DEVELOPMENT REVIEW BOARD
SUPPLEMENTAL SUBMITTAL

PROJECT NO. PR-2019-002184 (1001993)
Application No. SI-2019-00379

SUBMITTAL DESCRIPTION: Revised Site Plan Set; Infrastructure List; and Responses to Staff Comments Memo.

Re: Project Number: PR-2018-002184; Application Number: SI-2019-00379; Guardian Storage Site Plan-DRB Responses to Staff Comments

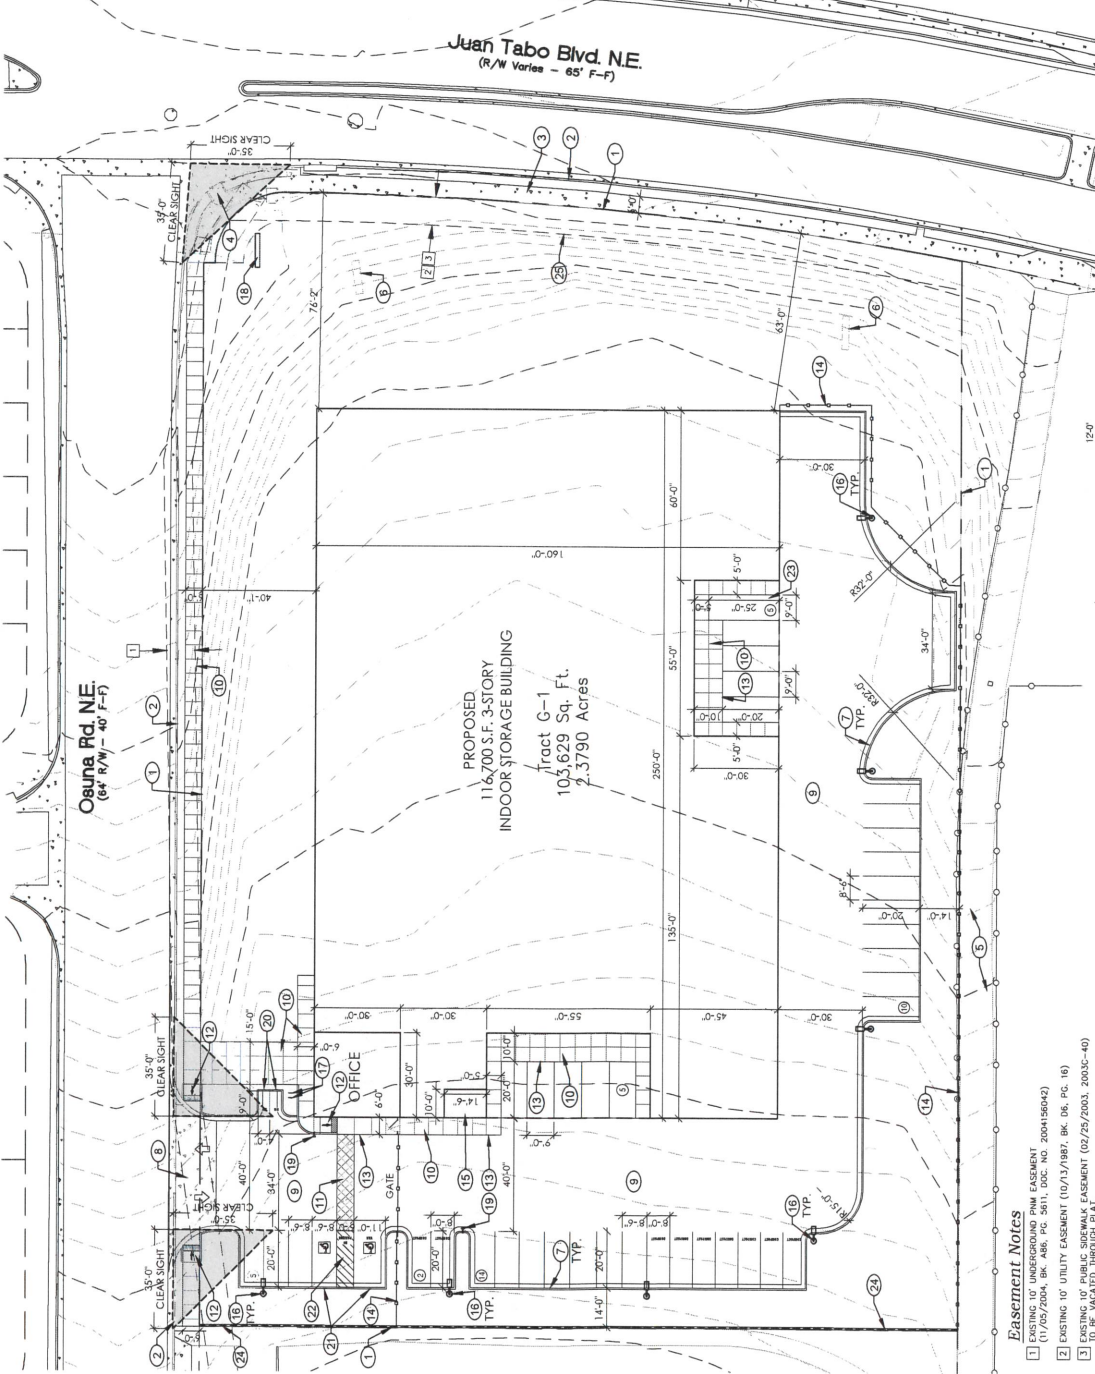
3. *Confirm the number of parking spaces.*

4. *No loading spaces are proposed, and 3 loading spaces are required.*

3. Both frontages are greater than 100 feet and exceed design requirements by incorporating two of the required features:
 - b. Color and material changes throughout the façade every 36' 3" linear feet and extends at least 20 percent of the façade.
 - e. Changes in parapet height occurring every 36' 3".
6. *Clarify how fencing requirements in 14-16-4-3(D)(28) are met, the fencing appears to stop before the property ends and does not appear to be opaque.*

7. *See 5-3-(D)(3)(b) network of walkways for required walkways- the walkways provided are too narrow.*

16. *Transportation comment at December 18, 2019 hearing: A 10-foot right-of-way easement is required along Juan Tabo Boulevard per DMD.*

Applicant Response: The parking space calculations are cited on the site plan. The site meets the required 41 parking spaces required for a 115,800 square feet Self-Storage facility. See additional response regarding loading spaces below.

Applicant Response: *IDO Table 5-5-7: Off-Street Loading Space Requirements* outlines the minimum spaces needed for “Non-residential Zone Districts” and “All Other Zone Districts”. The subject property is zoned MX-L (a mixed-use zone) therefore, it falls into the latter category as defined by the IDO. As such the minimum requirement is *1 space per building on sites with adequate unbuilt lot area to accommodate a loading space meeting the standards of Subsection 14-16-5-5(H).*

To meet this requirement, the site plan has been reconfigured to add one 9 ft. x 25 ft. loading space to the loading area on the south side of the building. The Applicant

Applicant Response: The fencing along the south side of the site will be modified to show a 6' solid opaque wall, as stated in the above IDO section. The Applicant is requesting the DRB consider a combination wall/fence on in this location as it abuts a neighborhood trail, that provides connection to the City's multi-use trail. The combination fence would contain opaque material up to 3' and 5' of tubular steel view fencing. This would make a more pleasant experience for users of the trail, provide visual access to the landscaping, and retain security for the site. The Site Plan will be modified to reflect the view fencing if it is approved by DRB.

Applicant Response: The walkway on the north side of the building (facing Osuna Road), at the only pedestrian entrance to the building, has been widened to 15-feet, per *IDO Section 5-3(D)(3)(d)*.

Applicant response: The Site Plan shows the 10-foot sidewalk easement along Juan Tabo Boulevard. It will be dedicated as right-of-way by future plat action.

DRAINAGE SUMMARY

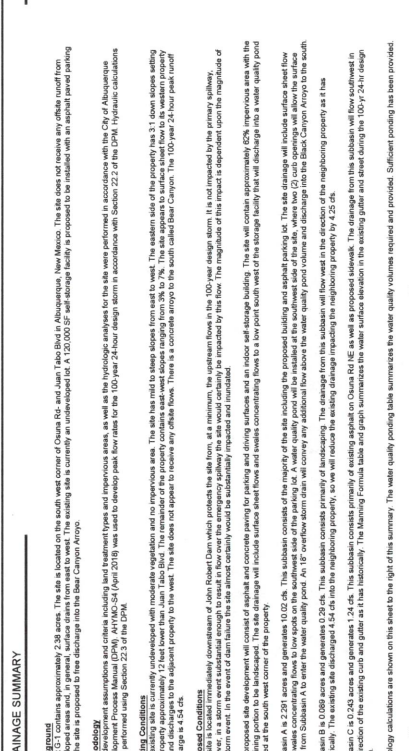
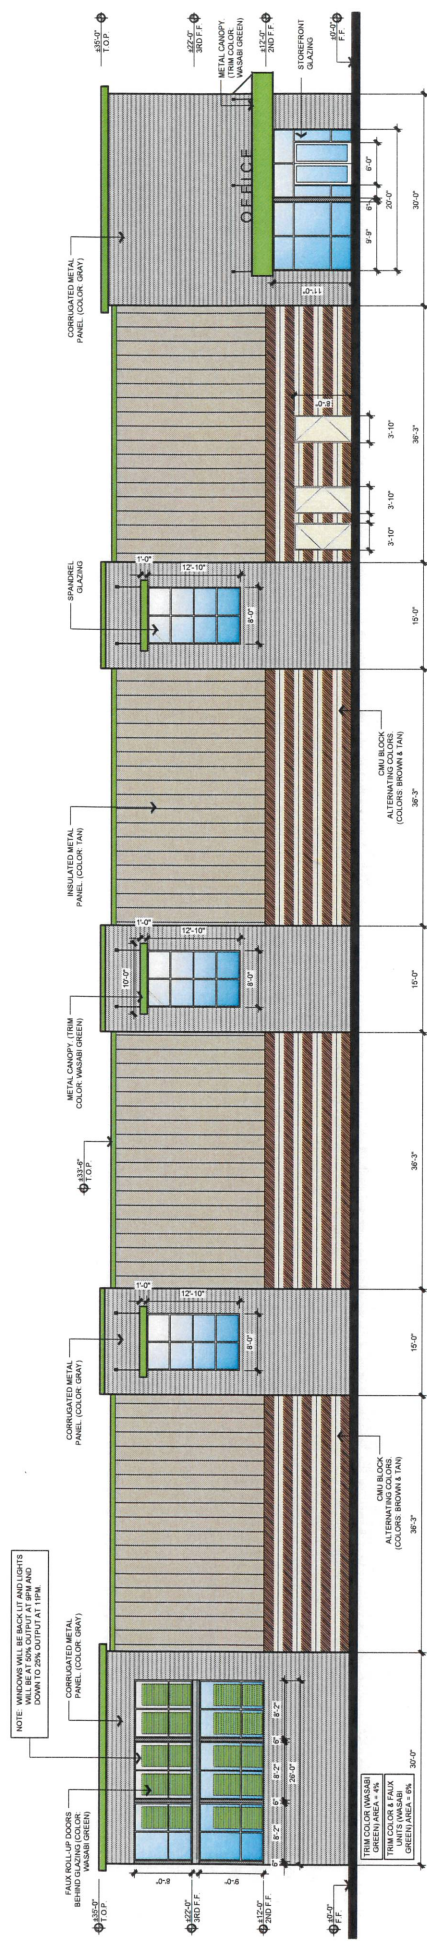
15. *Please provide elevations or a horizontal profile to illustrate the steep slopes.*

Applicant response: Elevations illustrating steep slopes are provided in the revised Grading and Drainage Plan. Additionally, a Street Elevation Study exhibit was submitted with the original application which shows the building elevation and slope along Juan Tabo Boulevard and Osuna Road.

OSUNA ROAD ELEVATION 1
1/8" = 1'-0"

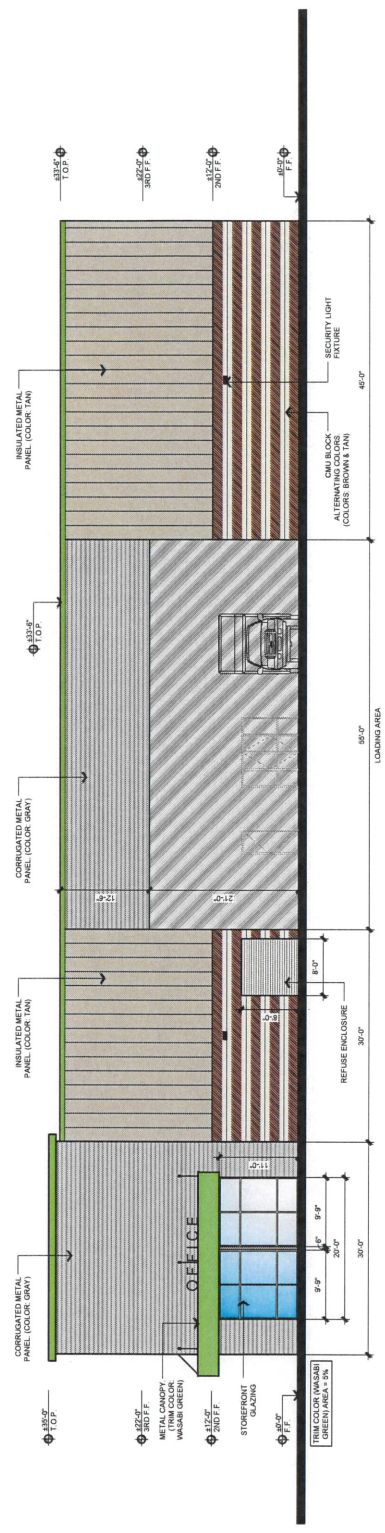
5. *Make sure that façade design in 14-16- 5-11 is being met.*

11. *Please confirm the spandrel windows are opaque and not see through. Will these windows have lighting?*

13. *Do building colors meet 5-2(H)(1)(a) for reflectivity. Please provide information for the colors used in the building.*

14. *Please clarify the shade of green, Pursuant to 5-2(H)(1)(b) colors must blend into the surrounding environment, yellow ochres, browns, dull reds and grey greens- please confirm that is a grey green.*

Applicant Response: The following responses pertain to *IDO Section 5-11(E)(2)(a):*

1. The first floor is 12' which provides a sense of human scale with the subsequent floors being 10', respectively. There are building material changes from the ground floor to the upper floors, providing a clear architectural distinction.
2. The building façades facing the public streets of Juan Tabo Boulevard and Osuna Road incorporate three of required façade features, exceeding the requirement of two. They include:
 - b. Material changes with windows at the upper floors less than 40 linear feet apart.
 - c. Primary pedestrian entrance on Osuna Road façade.
 - d. Window elements contain canopies and shade awnings with accent color.

These features comprise 42% (exceeding the required 30%) of the Osuna Road façade and 53% of the Juan Tabo Boulevard façade. On both streets, they occur every 36' 3".

Applicant Response: Correct. The spandrel windows are opaque and not see through. The spandrel windows do not have lighting.

Applicant Response: Yes, these colors are below the 50% threshold per *IDO Section 5-2(H)(1)(a)*. A color and reflectivity table has been added to the elevation sheets for all painted exterior surfaces.

Applicant response: The shade of green illustrated on the elevations is Wasabi Green, a trim color. *Per 5-2(H)(1)(b)1, trim materials constituting less than 20% of the façade may be any color and the design is in compliance.* Please see below for percentage of trim on each elevation:

Osuna Rd. Elevation
Trim Color w/Faux Units: 6%

West Elevation
Trim Color: 5%

South Elevation
Trim Color w/Faux Units: 7%

East Elevation
Trim Color w/Faux Units: 12%

Total façade percentage with faux units = 7.5%
